# Technical Bulletin

### Self-Leveling Suspension, Error Message Displayed in Multi-Function Display

43 06 01 Sept. 22, 2006 2010605 Supersedes T.B. Group 43 number 04-01 dated May 11, 2004 due to updated information.

## Identifying Sensors

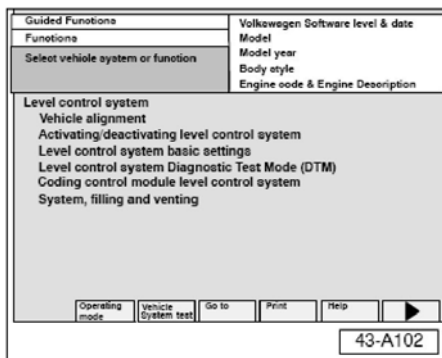
Check manufacturing date -arrow- of all leveling sensors.

If leveling sensor manufacturing date is between February 01, 2003 and July 22, 2003 (ddmmyy):

- Replace leveling sensor, see Repair Manual Group 43, Self-Leveling Suspension.

If leveling sensor manufacturing date is not between February 01, 2003 and July 22, 2003:

- No service action required.
